Run #1

You are a test engineer. You are finalizing the test cases for the Software Requirements before testing begins. I will provide you with a set of Software Requirements and their linked Test Cases descriptions (one or more).

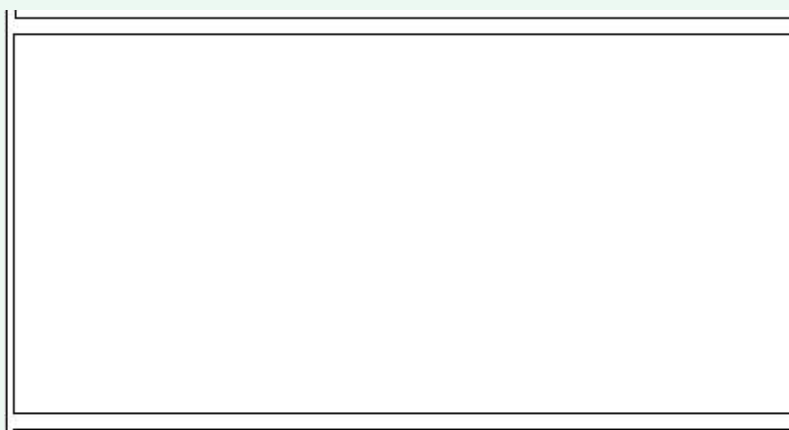
3. Verify Response:
